CITY OF ALBUQUERQUE

RE: **Costco**
1420 Renaissance Blvd. NE
Grading and Drainage Plan
Engineers Stamp Date 12/1/2021 (F16D003G)

Based upon the information provided in your submittal received 3/3/22, this plan cannot be approved until the following corrections are made:

COVER SHEET
1420 RENAISSANCE BLVD NE
ALBUQUERQUE, NM 87107
COSTCO WAREHOUSE #116

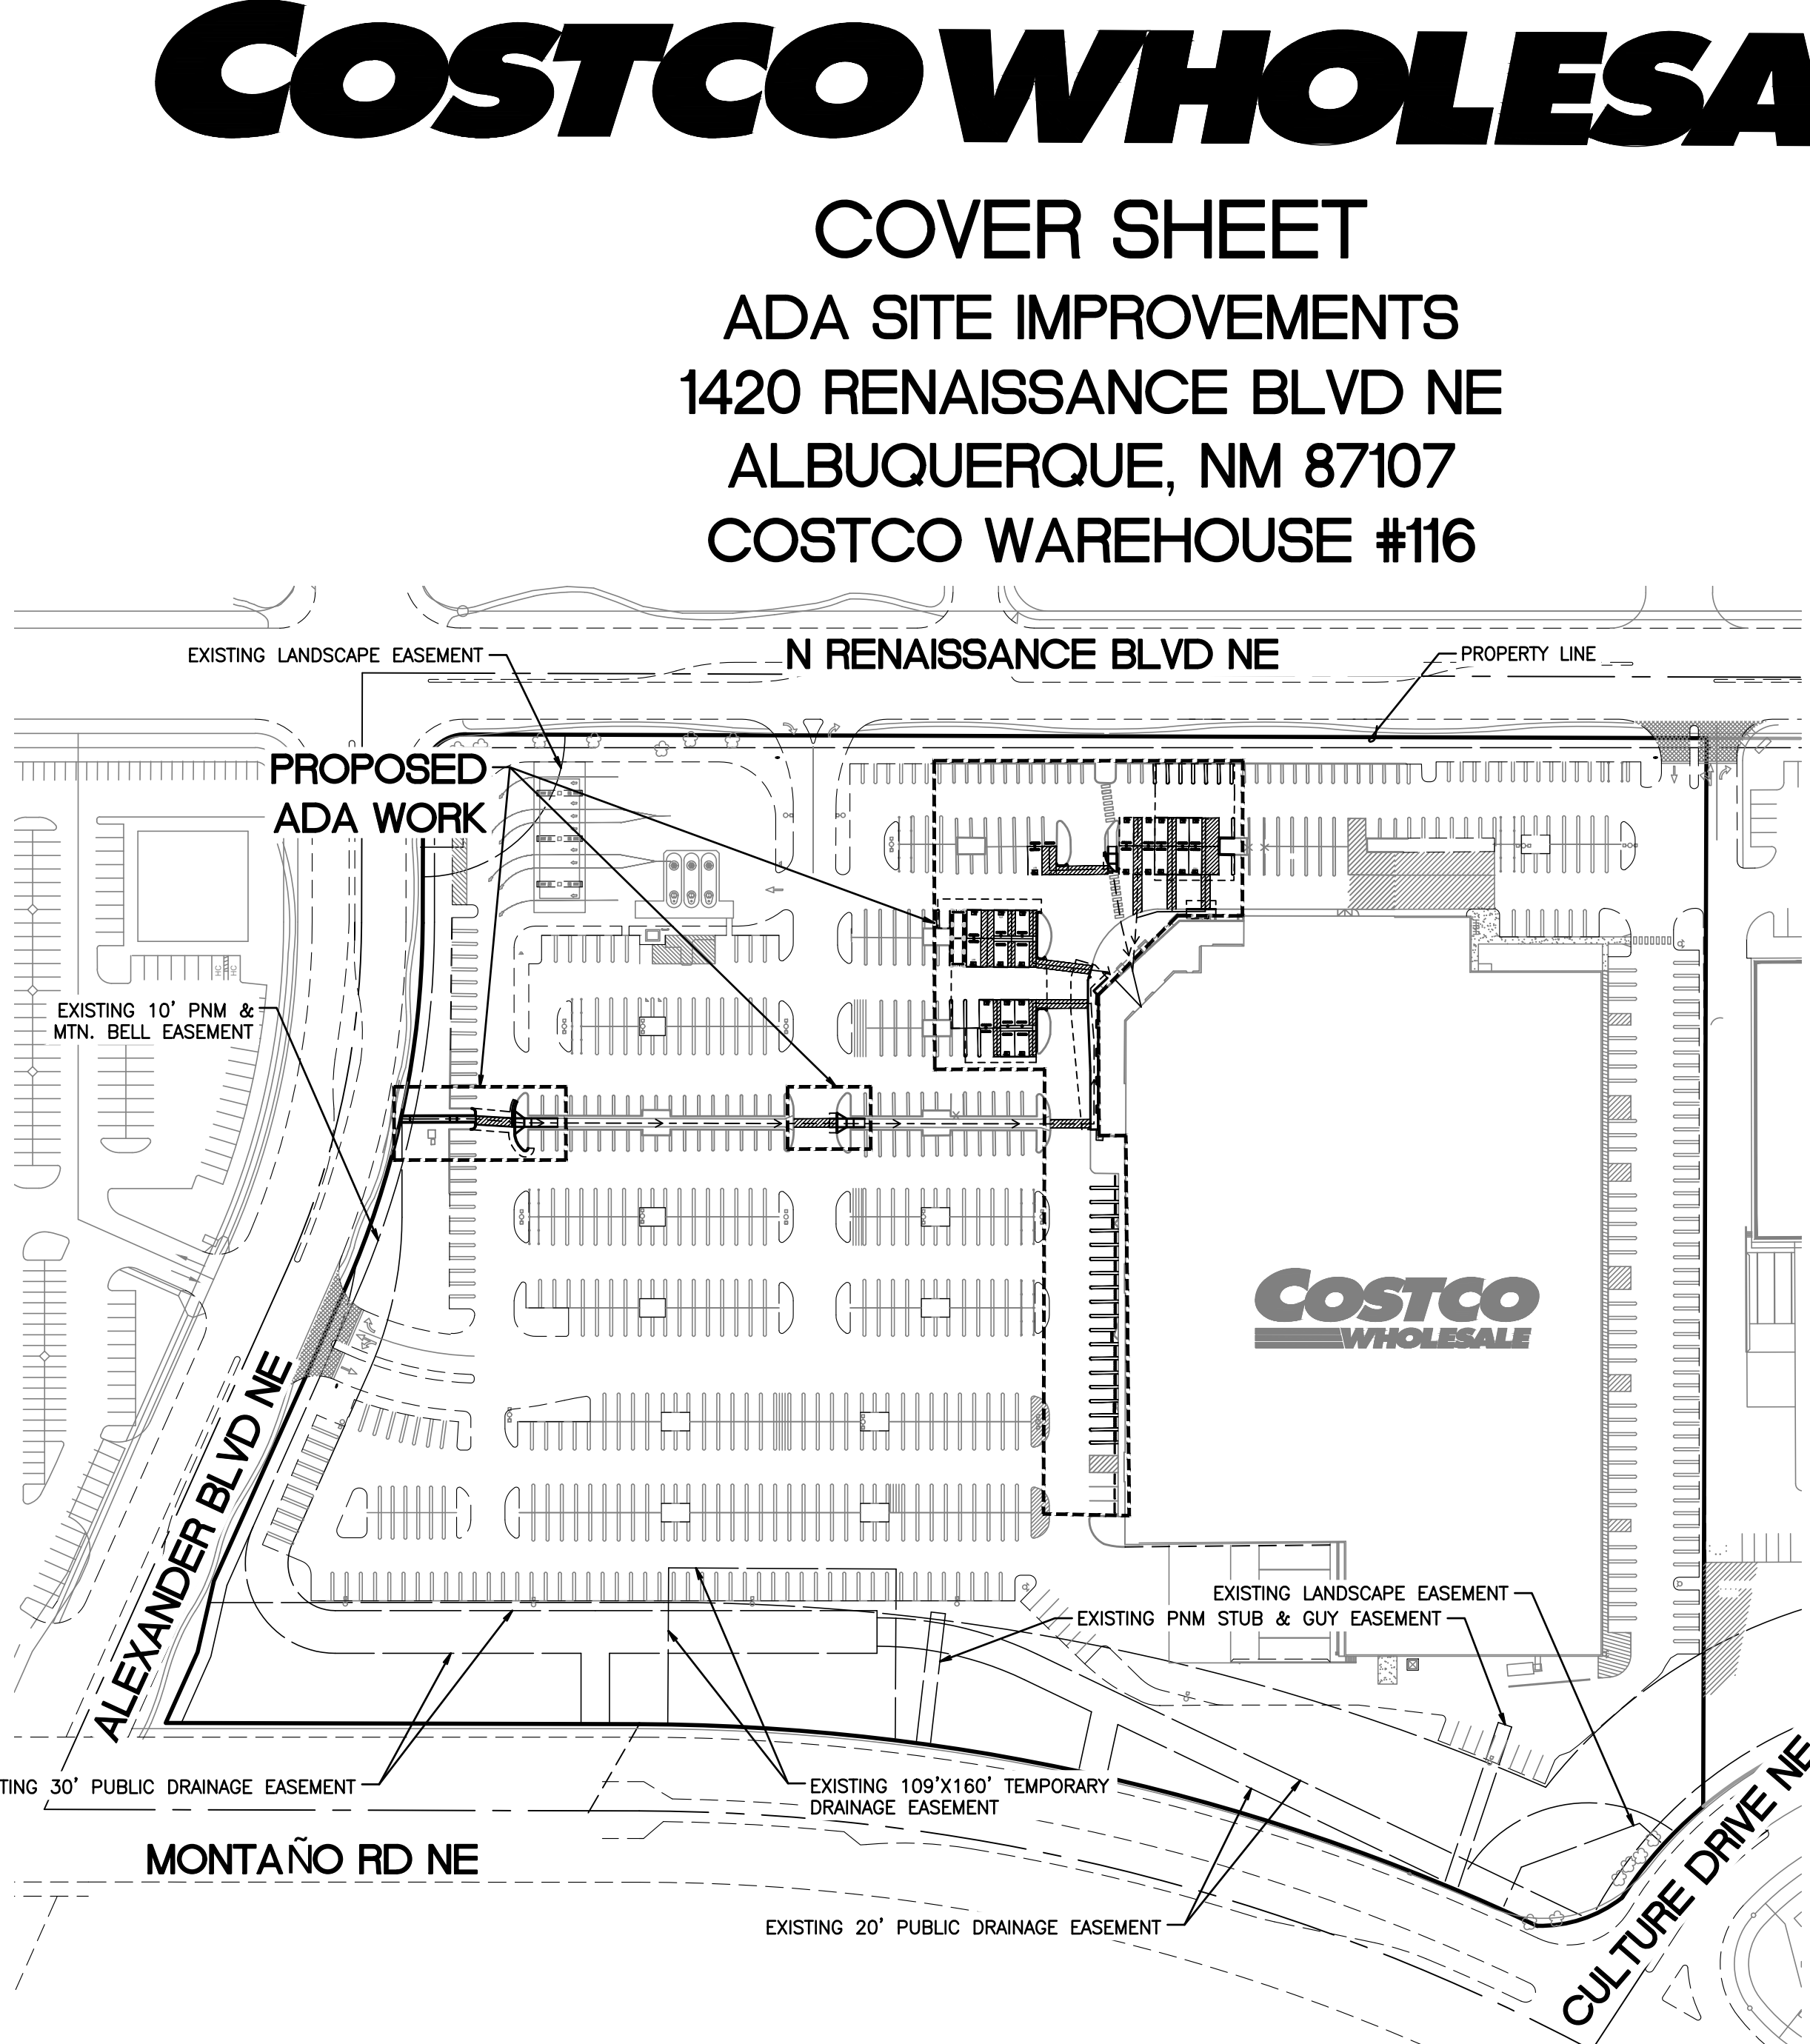
1. It is apparent that a lot of work went into preparing these plans, but there is a large amount of work here that is not needed for this submittal and should be left off. There should be no cover sheet, general notes, paving or other construction details other than grading and drainage. There should be no notes on the grading and drainage that deal with other aspects of construction such as accessibility or striping.

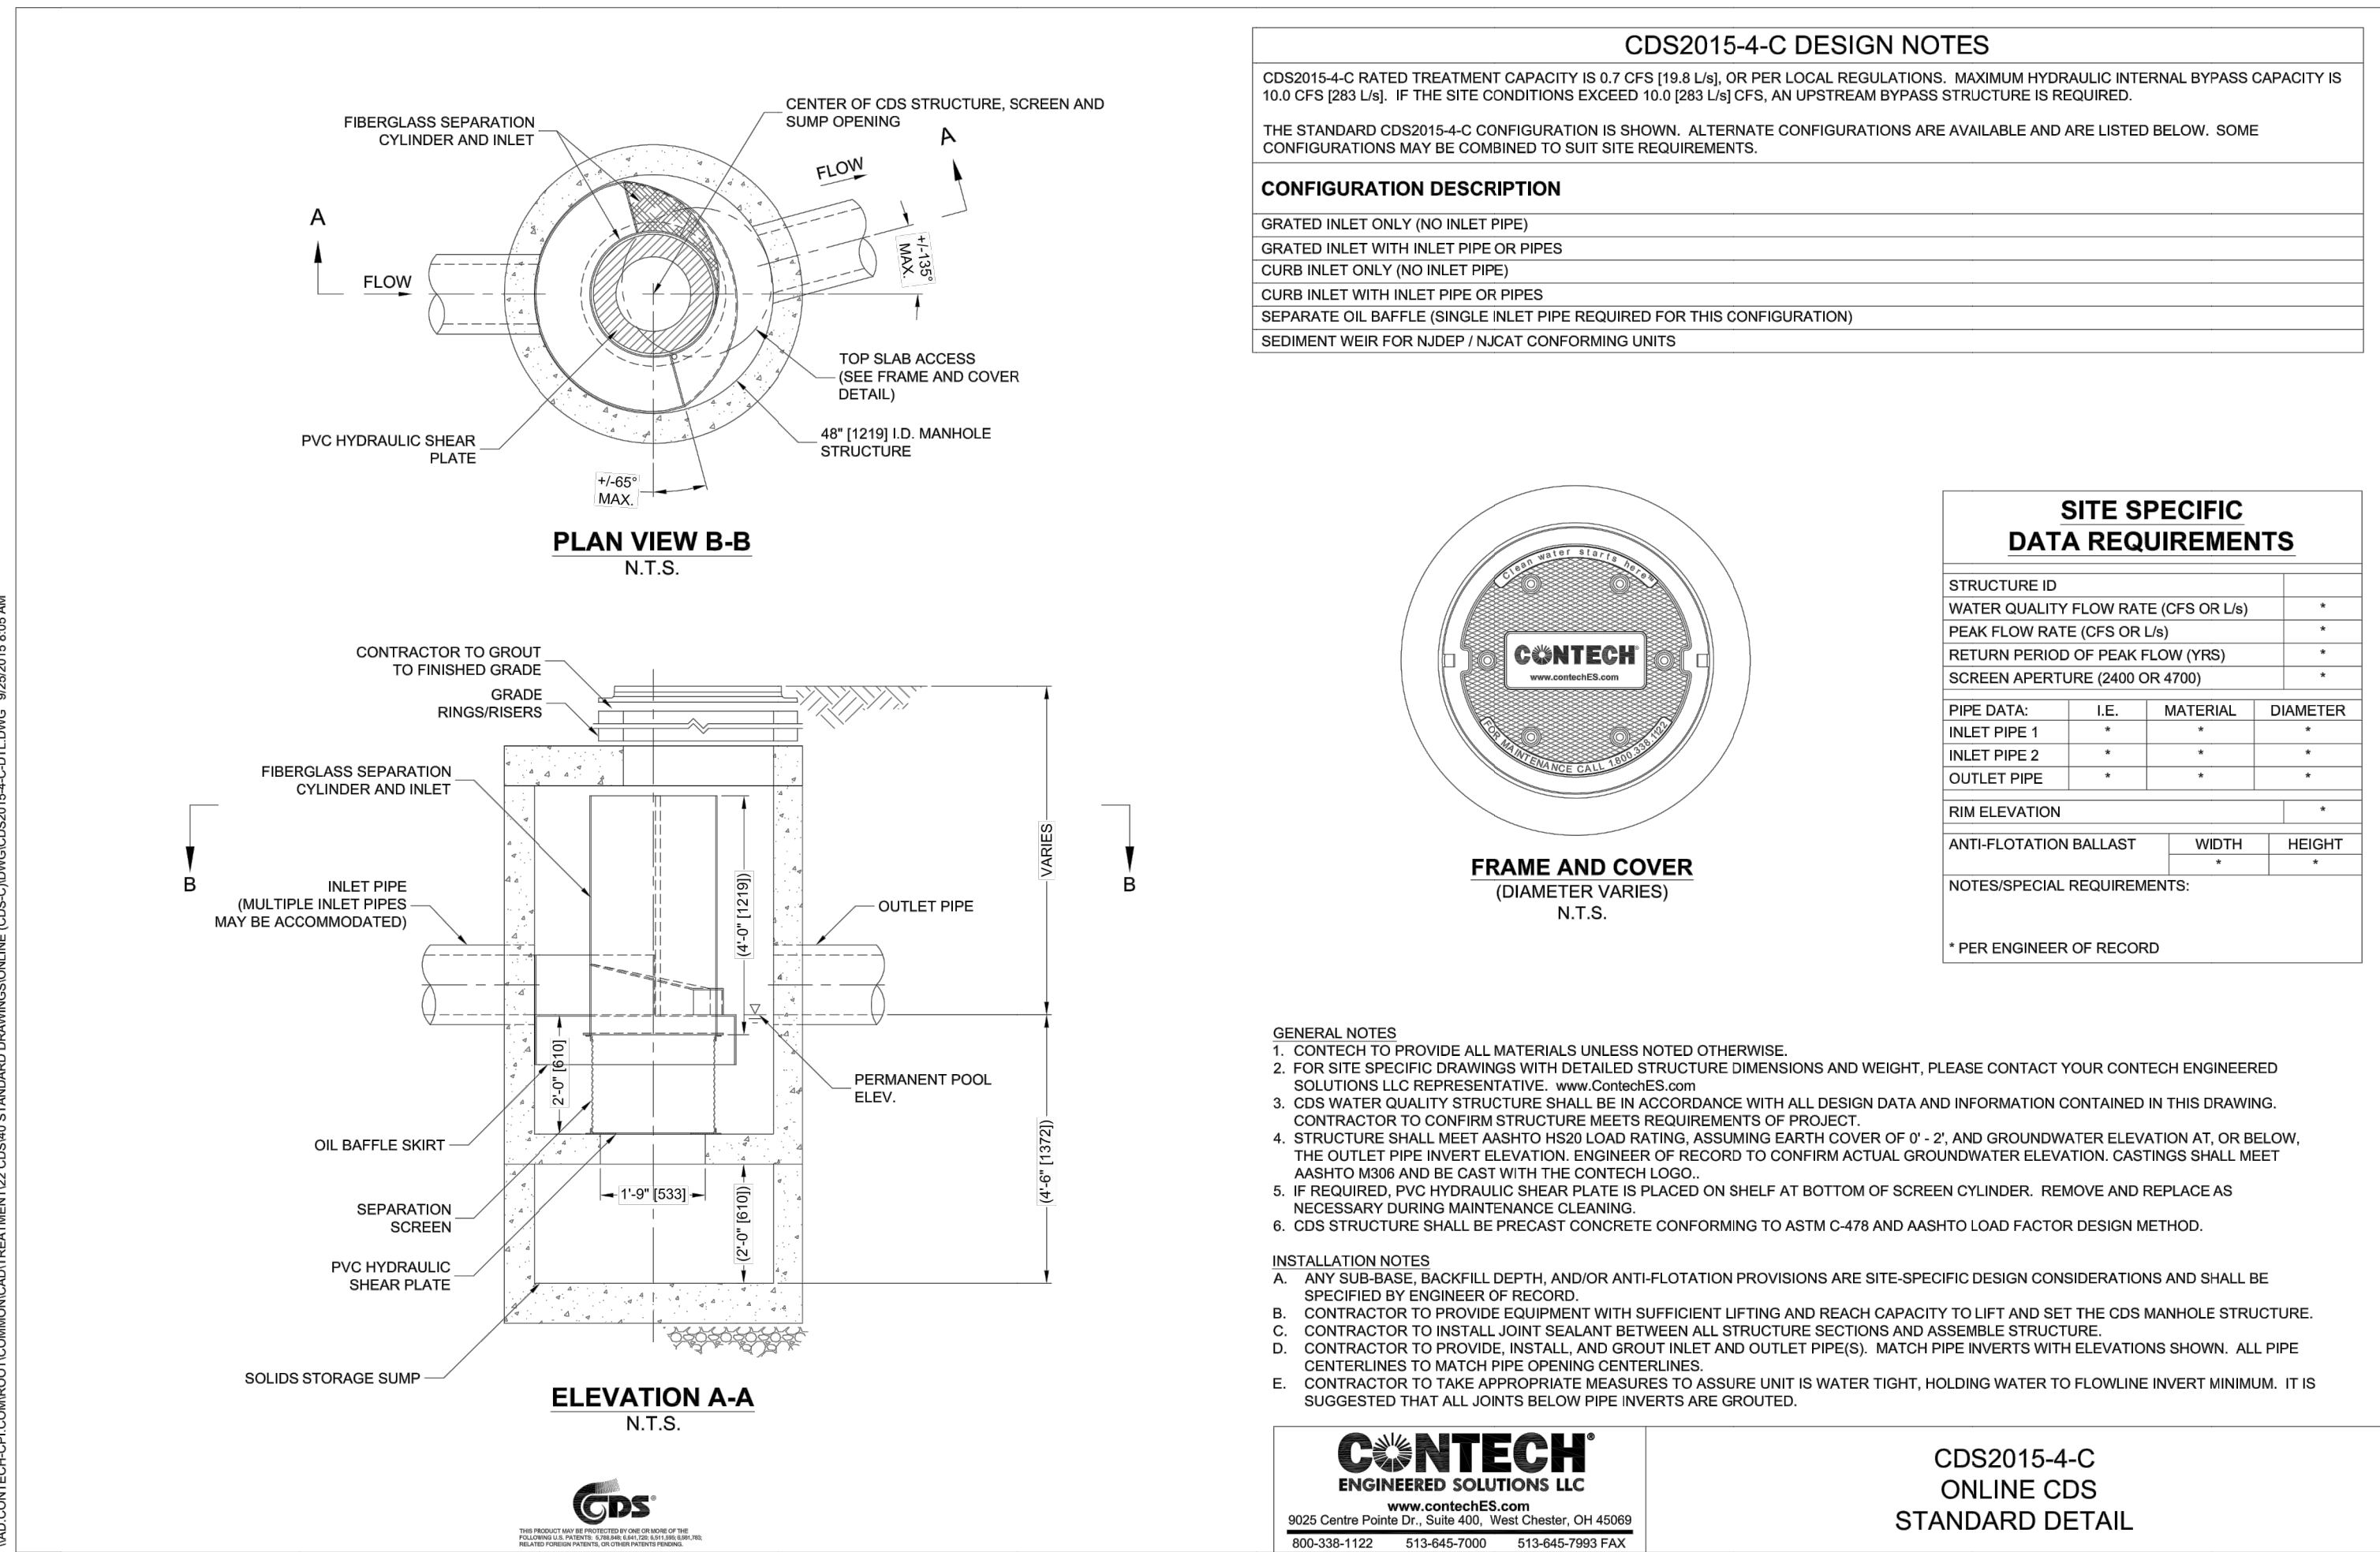
- e. Please provide the FIRM Map and flood plain note with effective date.
 - f. Please provide a legal Description of the property.
3. There are no calculations shown for runoff and ponding. Please use the procedure for 40 acre and smaller basins as outlined in Development Process Manual (DPM) Article 6-2(a). Please provide both the existing conditions and proposed conditions for the 100 year-6 hour storm event.

4. Please calculate and provide management onsite for the Stormwater Quality Volume (SWQV) in accordance with the new drainage ordinance, § 14-5-2-6 (H) enacted 10/2/18

(Council Bill C/S O-18-2). Please show the top and bottom of the ponds along with the volume for each pond. The onsite drainage should be directed to these ponds prior to being collected in a private unground drainage system. Please follow the DPM (signed 06/08/20) Article 6-12 Stormwater Quality and Low-Impact Development for the sizing calculations. To calculate the required SWQV, multiply the impervious area draining to the BMP by 0.42 inches for new development sites and 0.26 inches for redevelopment sites. The calculations of both the required and the provided volume of each BMP must be shown on the Grading and Drainage Plan. Each BMP should be labeled on the Grading and Drainage Plan with the required SWQV and associated water surface elevation and the 100-year water surface elevation. Landscaping of surface BMPs is also required to be noted on the Grading and Drainage Plan. This site qualifies as redevelopment so use the smaller number.

- 5.
6. Please provide the SWQV calculations for each basin draining to each pond. The stormwater quality ponds need to be sized for the areas draining to them. Typically these flows are directed to landscaping areas which are graded to hold the SWQV.
7. I see on your plan that Grading Area 4 is proposed to use a CDS manhole to capture and treat storm flows. The City does not allow these types of systems to be used as once they are a maintenance problem and do not get serviced regularly. The City uses retention of SWQV in ponds or if need be in underground systems.
